SPRINGHILL COMMERCIAL PARK SUBDIVISION, **UNIT FOUR**

APPLICATION NUMBER 4 DATE July 20, 2006

SPRINGHILL COMMERCIAL PARK SUBDIVISION, UNIT FOUR

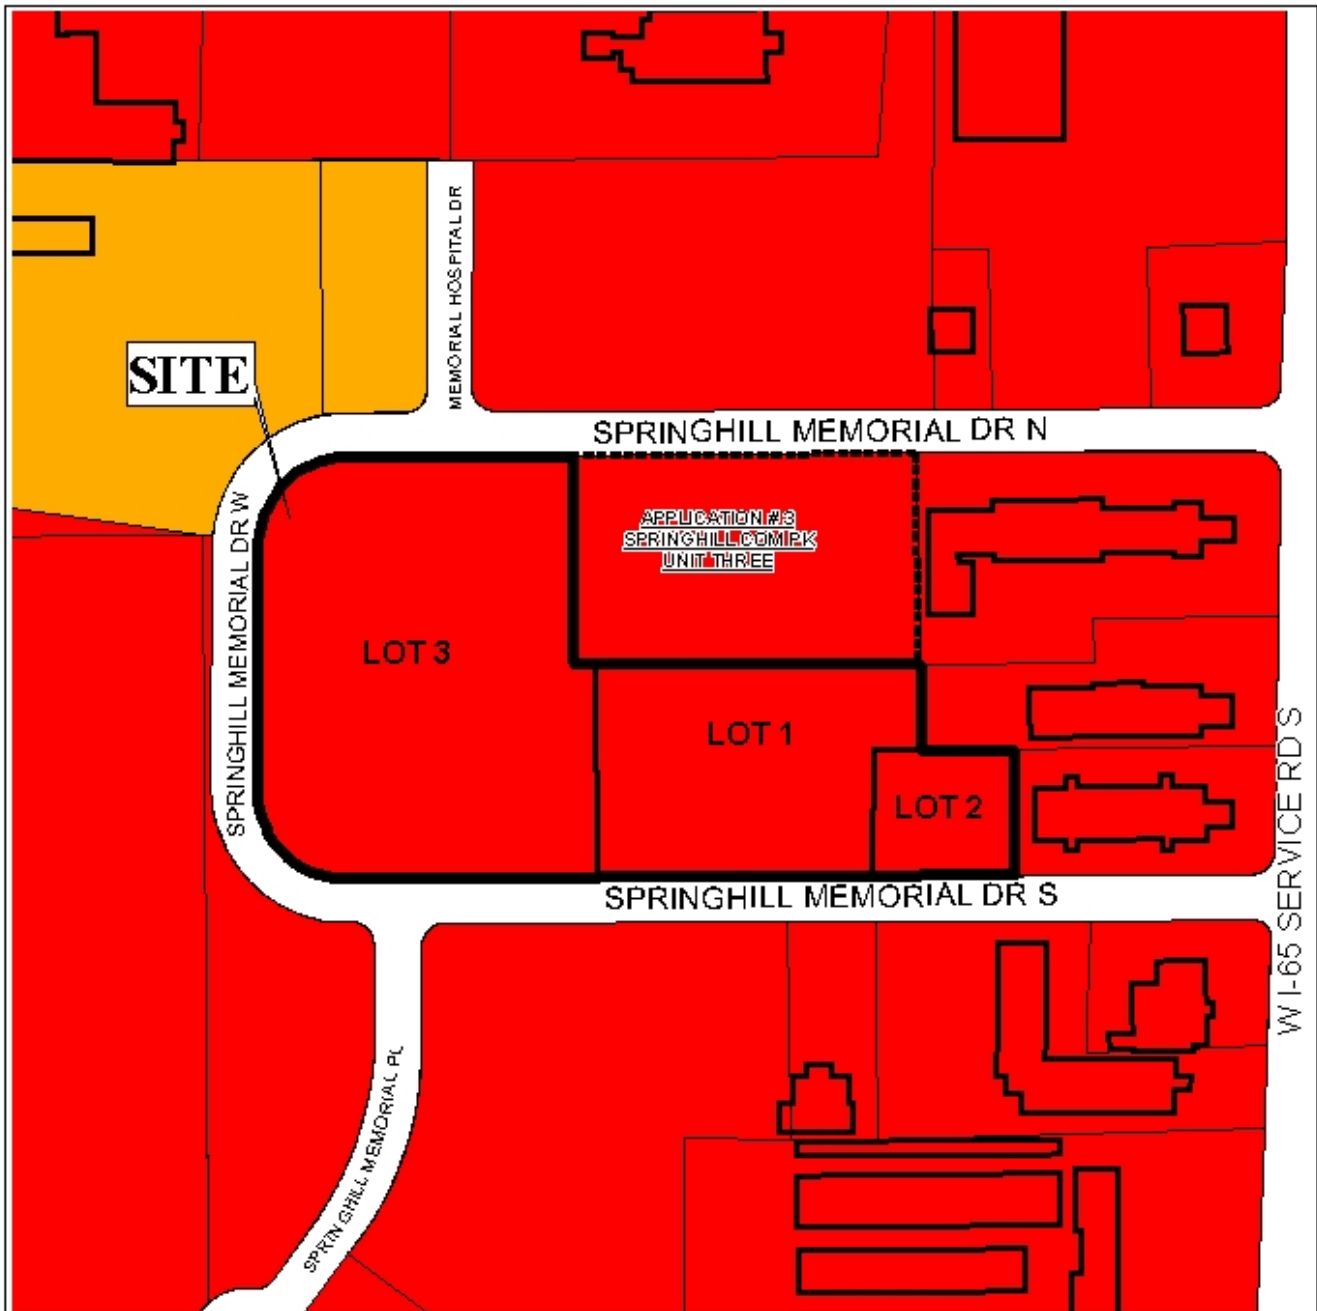
The site fronts Springhill Memorial Drive, which has a 50-foot right-of-way. As a means of access management, Lots 1 and 2 should be limited to a single curb cut each, and Lot 3 should be limited to three curb cuts, with size, location, and design subject to Traffic Engineering approval.

The 25-foot building setback lines are not shown but would be required on the final plat.

The plat meets the minimum requirements of the Subdivision Regulations and is recommended for Tentative Approval, subject to the following conditions: 1) that the plat is recorded simultaneously with that of Unit Three of Springhill Commercial Park Subdivision; 2) the placement of a note on the final plat stating that Lots 1 and 2 are limited to a single curb cut each, and that Lot 3 is limited to three curb cuts, with size, location, and design to be approved by Traffic Engineering; and 3) the depiction of the 25-foot building setback lines on the final plat.
